## Staff Report City of Richmond, Virginia

## Urban Design Committee

UDC 2022-08		Conceptual Location, Character, and Extent Review	Meeting Date: 8/4/2022
<b>Applicant/Petitioner</b>	L. Dexter Goode, Capital Projects Manager, Sr.		
<b>Project Description</b>	Conceptual location, character, and extent review of renovations to the existing Richmond Public Library – Downtown Branch		
<b>Project Location</b>			
<b>Address: 101 E. Franklin Street</b>			
<b>Property Owner: City of Richmond</b>			
<b>High-Level Details:</b>	<p>The applicant proposes a concept to demolish a portion of the existing library and construct a new and modernized addition. The new addition is designed to be a welcoming and accessible space for patrons with space to become an important community resource. Accessibility, health, efficiency and evolving community needs are taken into account by the design. Improvements to the site include public space improvements and the addition of underground parking, along with internal and external improvements to the existing building.</p>

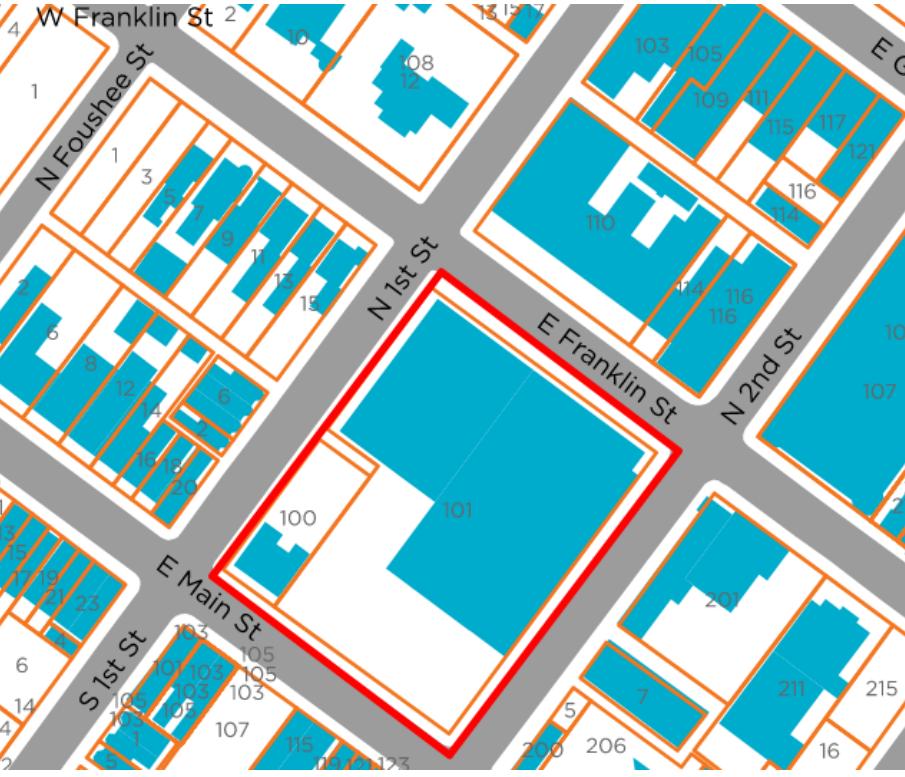
*The UDC provided a comment asking if the splashpad being located so close to the intersection of Franklin Street and 1<sup>st</sup> Street would create a conflict of children possibly running into the street. Staff and the Applicant point to other examples of splashpads similarly situated near intersections that use seating walls, landscaping, and stormwater infrastructure to indicate users into the proper area. These elements are not included in the Concept plan due to the level of detail required and will be fully detailed in the Final Application. Staff recommends that the final design include these elements for safety considerations.*
